SIB 64 01 26

RECALL 26V-096: CHECK AND REROUTE COCKPIT WIRING HARNESS

2026-03-06

This Service Information Bulletin (Revision 3) replaces SI B64 01 26 **dated March 2026**.

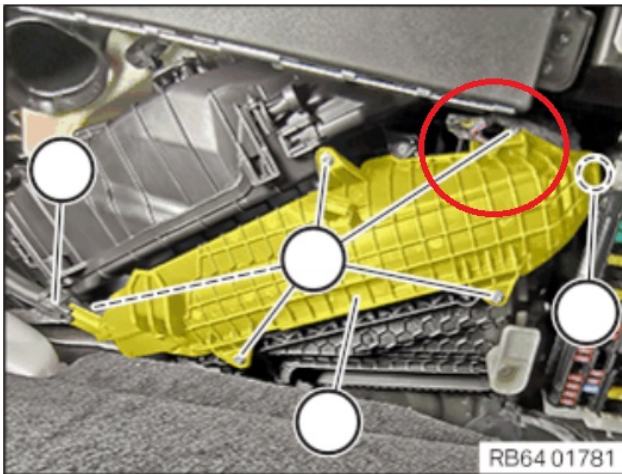
Follow Repair Instructions REP 64 31010 to access the cabin air nanofilter.

Check the vehicle wiring harness routing (circled) to ensure it is not pinched by the plastic cover over the filter.

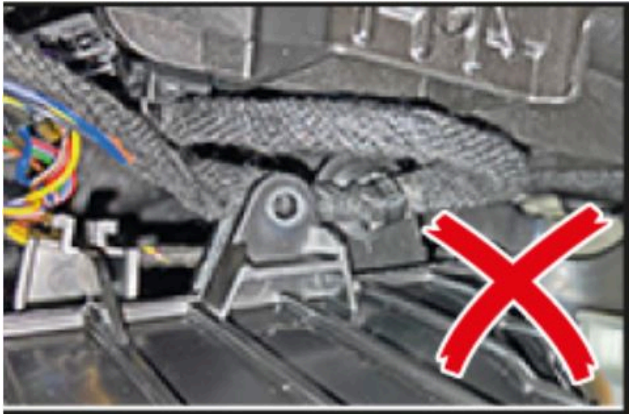
This is where the harness can be damaged when installing the cabin air filter cover screw.

This shows the harness damage; the sheathing has been abraded.

With the harness pulled out of the way, you can see the screw mounting hole for the cabin air filter cover.

Double check the routing of the harness prior to installing the screws for the cabin air filter cover.

The upper photo has the harness visible through the mounting hole. This positioning is not acceptable- the harness must be moved out of the way of the mounting screw.

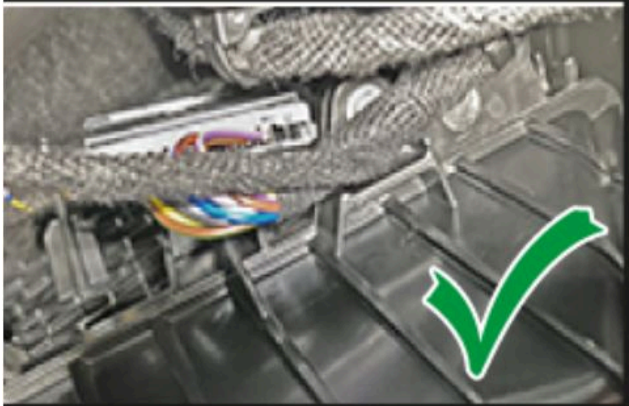
If the wiring harness has already been damaged during the installation of the cabin air filter cover, the damaged section of the wiring harness must be repaired.

The lower photo shows the harness positioned in front of the mounting screw, which is an acceptable routing.

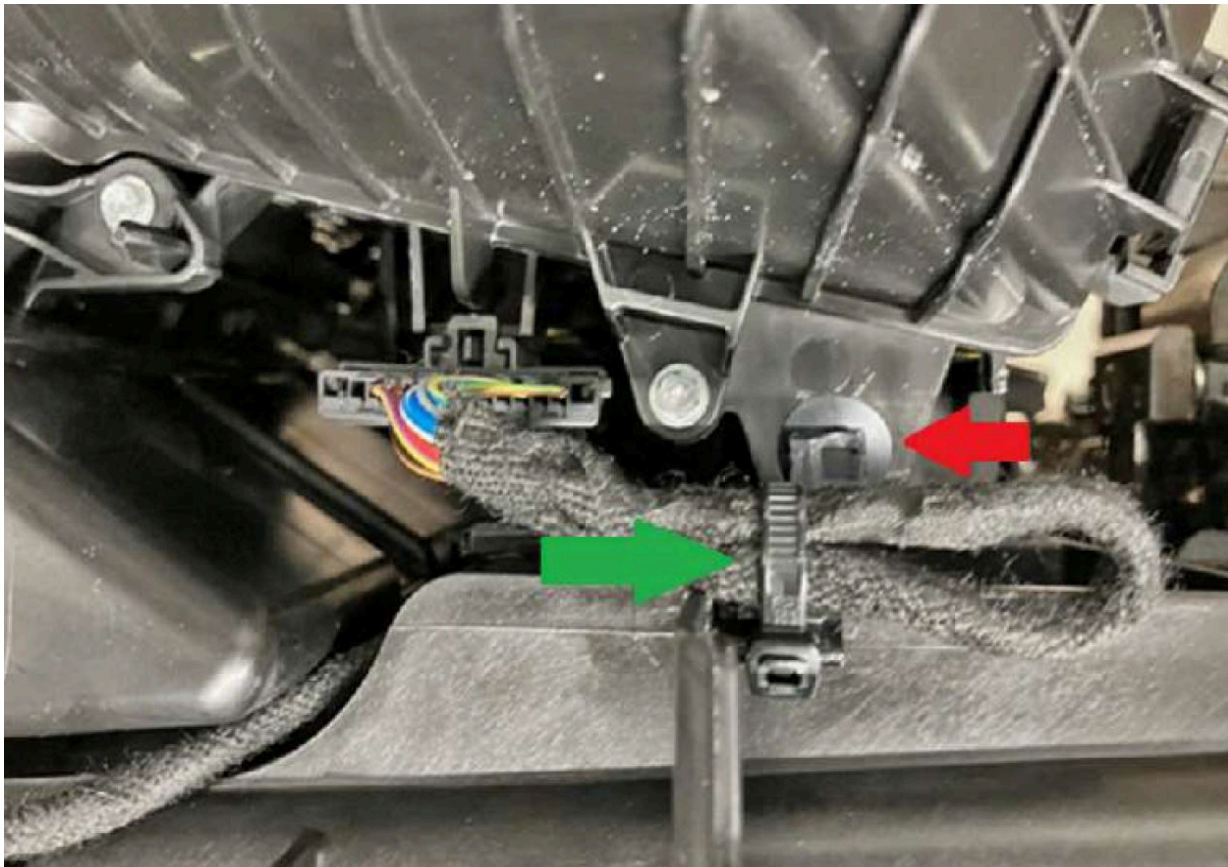
The original harness retainer must be disconnected. This is shown by the red arrow below. It can be left clipped into vehicle but must be disconnected from harness for strain relief.

Install a new harness retainer with cable strap on the instrument panel wiring harness, see green arrow.
